## **REMARKS**

### **AMENDMENTS TO THE DRAWINGS**

FIG. 1.

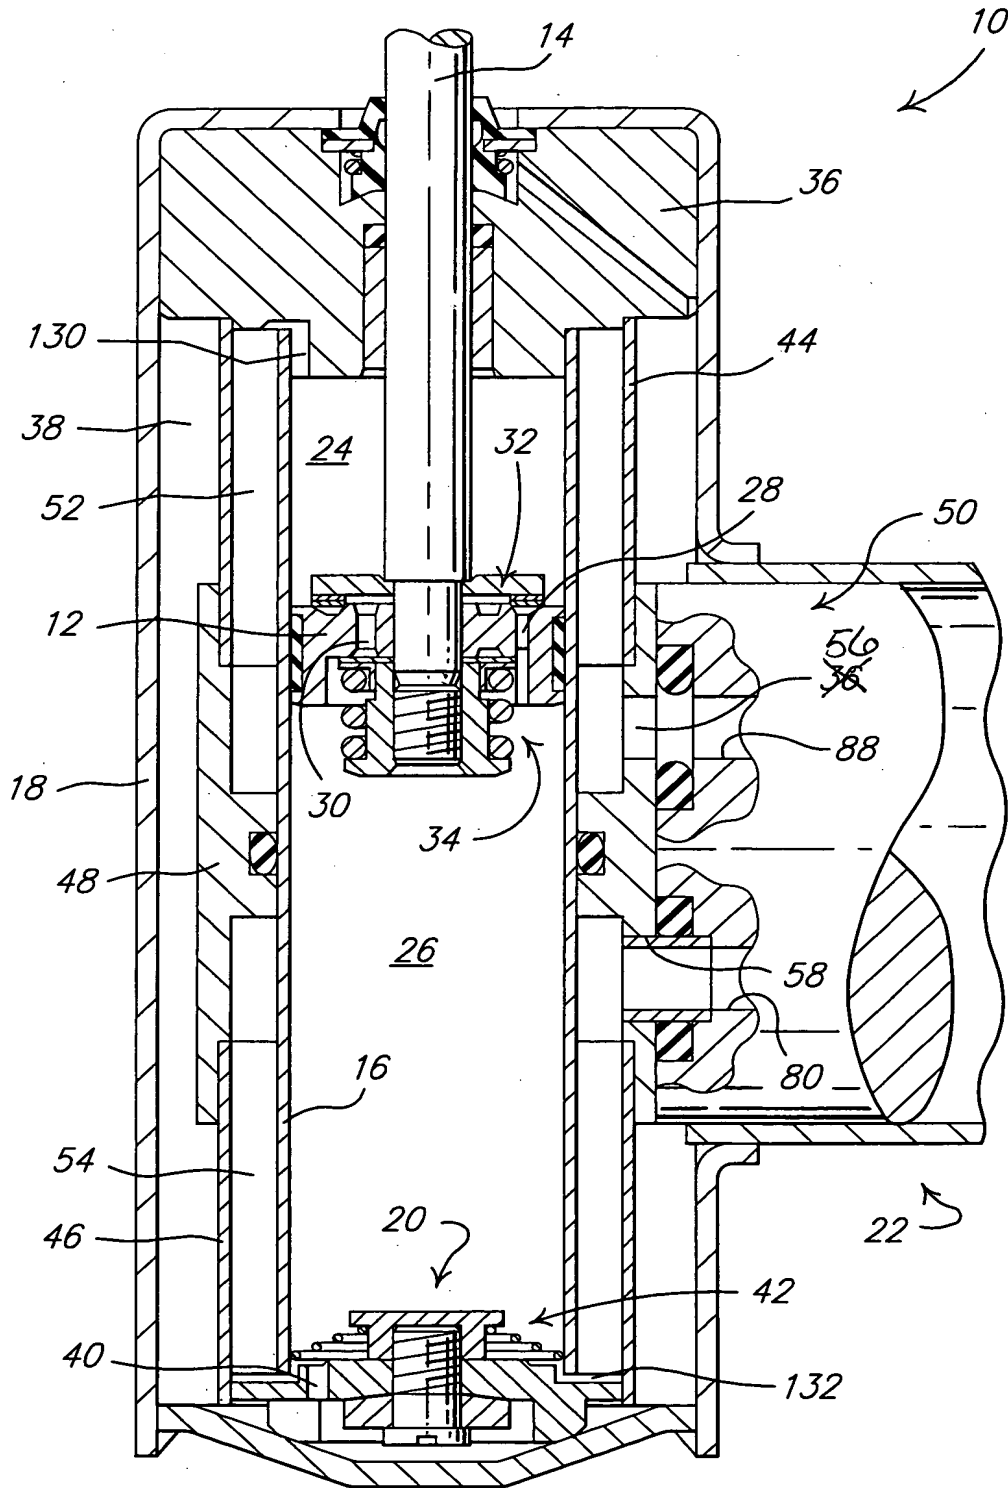
The drawings are objected to as failing to comply with 37 CFR 1.84(p)(4) because reference character "36" has been used to designate both the rebound outlet and the guide rod in figure 1. Figure 1 has been amended to illustrate the rebound outlet as being reference numeral 56 which is consistent with the specification. Withdrawal of the objection is respectfully requested.

Figure 1 – Please change reference numeral 36 to 56.

The attached "Replacement Sheet" of drawings includes changes to Figure 1. The attached "Replacement Sheet," which includes Figure 1, replaces the original sheet including Figure 1.
